PREVOST

SAFETY RECALL

Sr12-39

DATE : OCTOBER 2012	SECTION : 06-ELECTRICAL
SUBJECT : POWER CABLE RUBBING ISSUE

ITEM 1

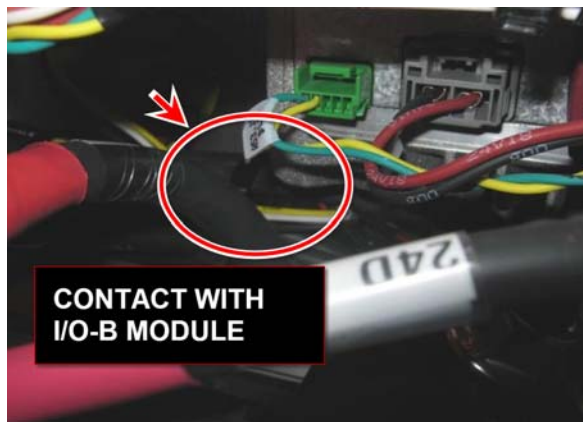
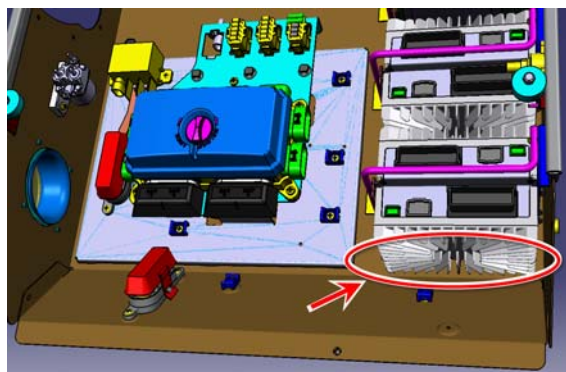
Make sure that no power cables come into contact with A53 I/O-B module. Move cables, reroute or use nylon cable ties as required.

Power cable 24EE1

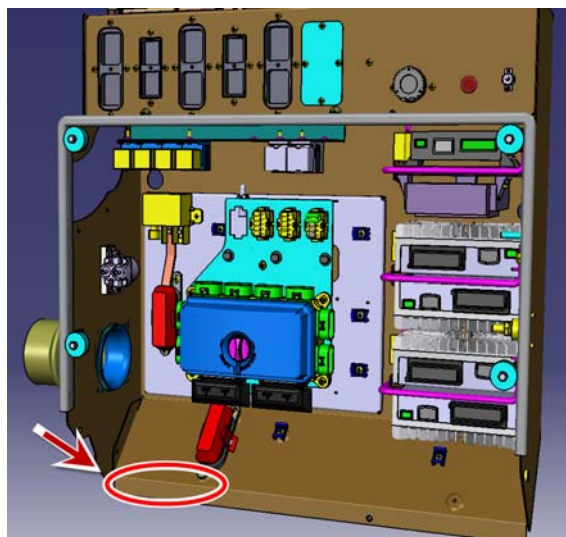
Make sure that power cable 24EE1 doesn't come into contact with sheet metal edge as shown on the image at right.

Power cable 101A connected to starter relay

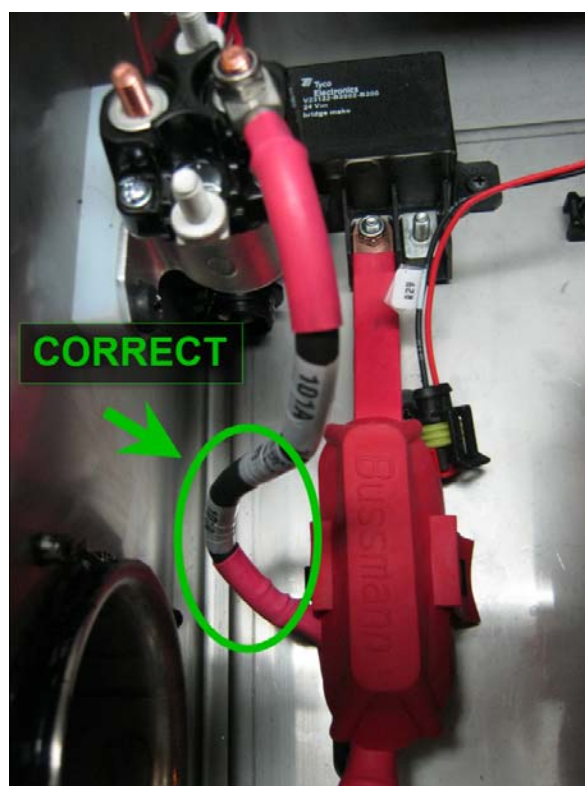
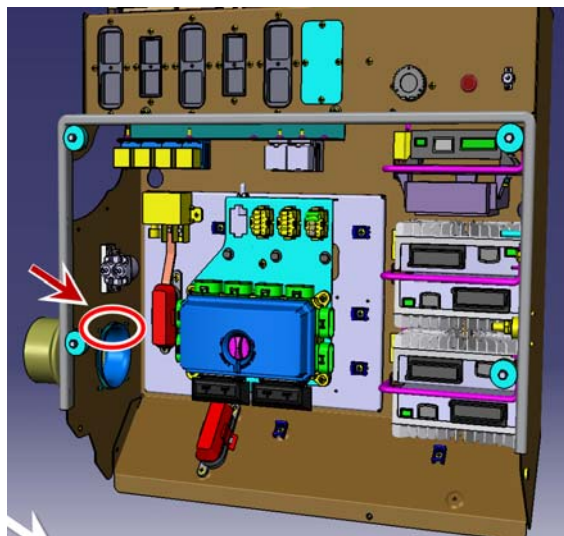
Eliminate any contact between power cable 101A and the cable grommet.

Power cables under the VECR

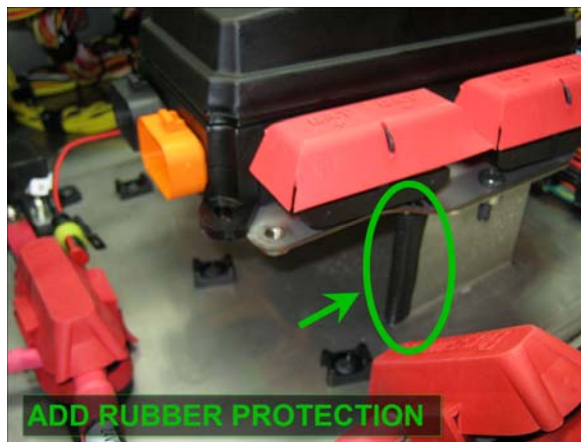
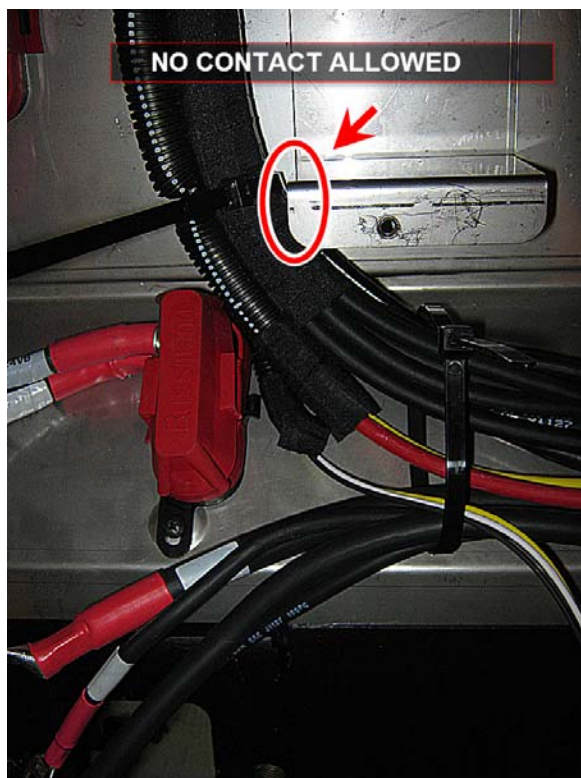
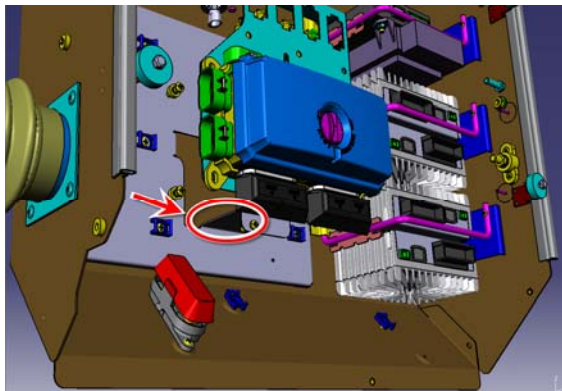
Make sure that power cables do not come into contact with the metal edge of VECR support bracket. Add rubber protection 420584.

Power cables 12VA, 24VA connected between battery terminals and battery equalizer

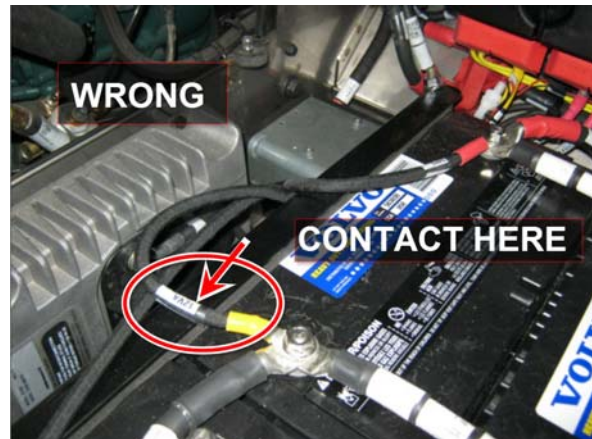
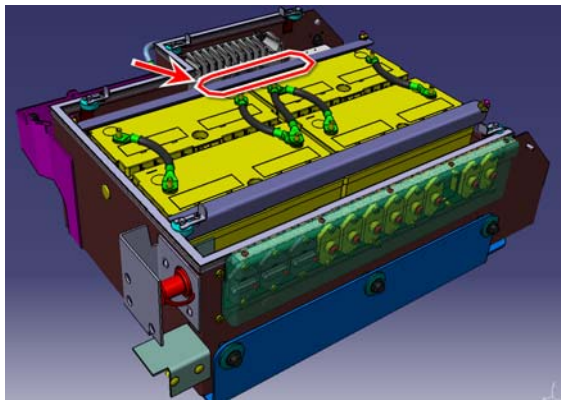
Loosen battery post nut and turn cable 12VA terminal to move the loop as shown on the image at right.

Arrange the cables in a different manner to avoid possible rubbing against the angle.

BATTERY POST NUT: 170 lbf-in

Booster block cable and power cables

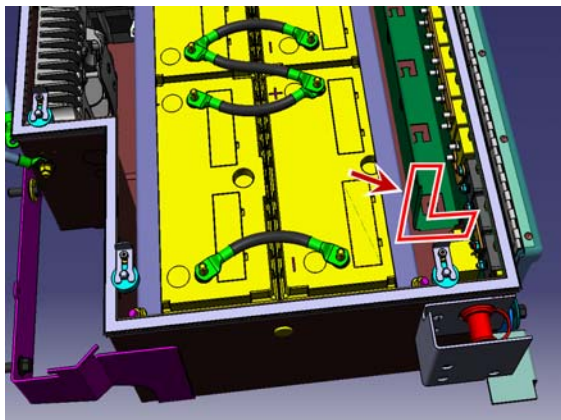
Check that the cables do not come into contact with the cable duct edge.

Battery cable touching the battery post

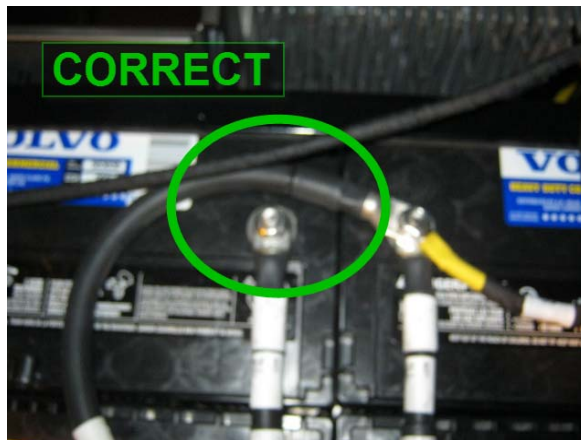
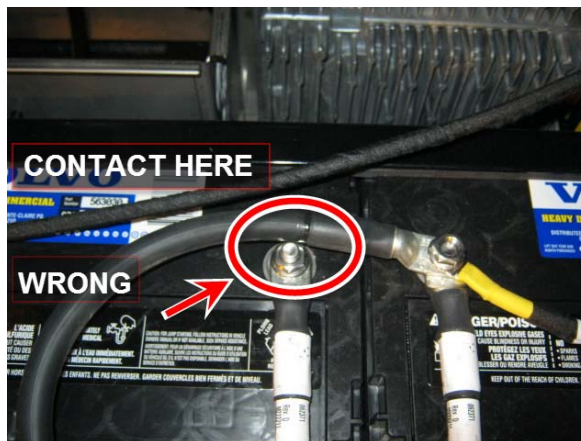
Rearrange the battery cable to prevent rubbing against battery post.

BATTERY POST NUT: 170 lbf-in

Battery cables connected to circuit breakers

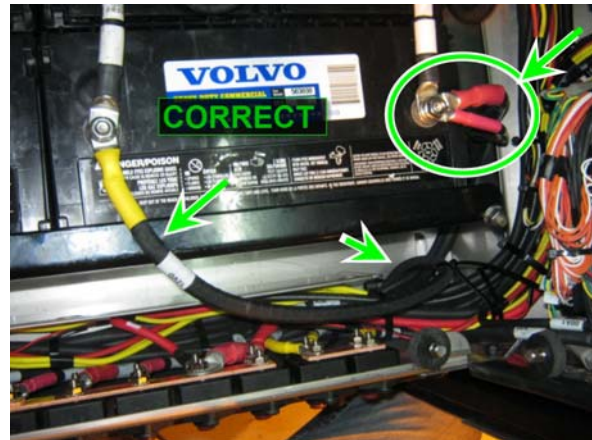
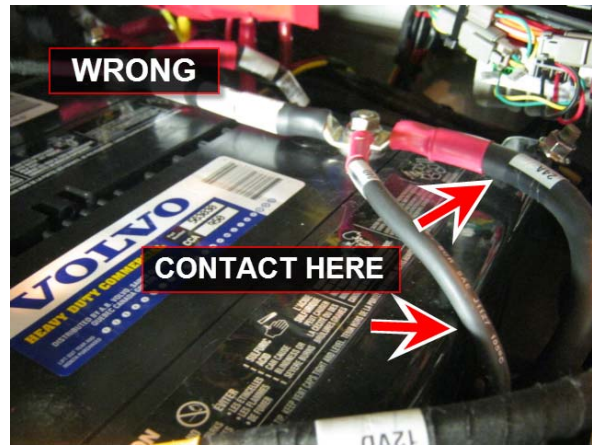
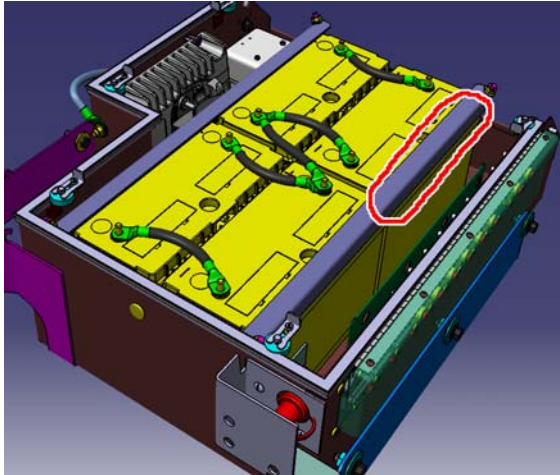
Rearrange the battery cables to prevent rubbing against the angle and other edges. Loosen battery post nut and rotate the battery cables as shown.

BATTERY POST NUT: 170 lbf-in

Power cable 24EE1 connected to relay R1

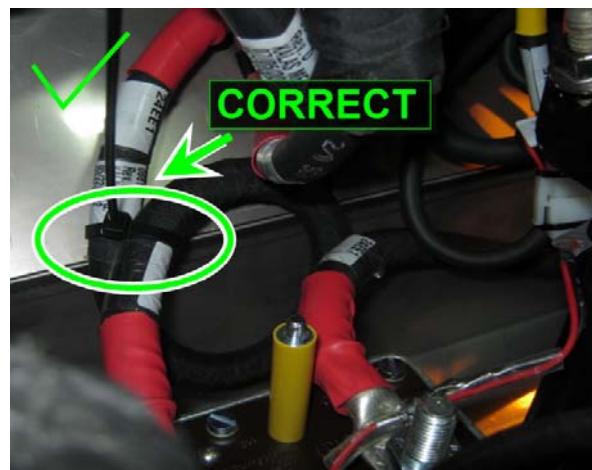
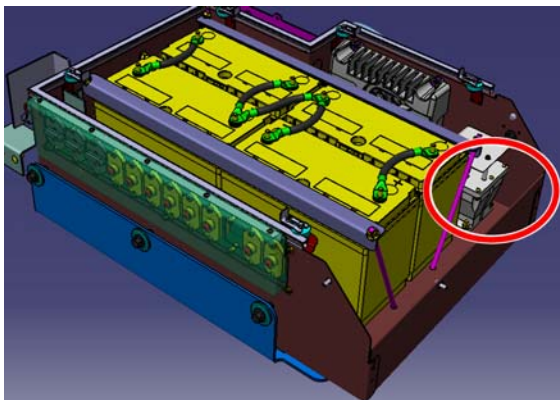
Tie the cable 24EE1 loop to prevent it to come into contact with the sheet metal edge.
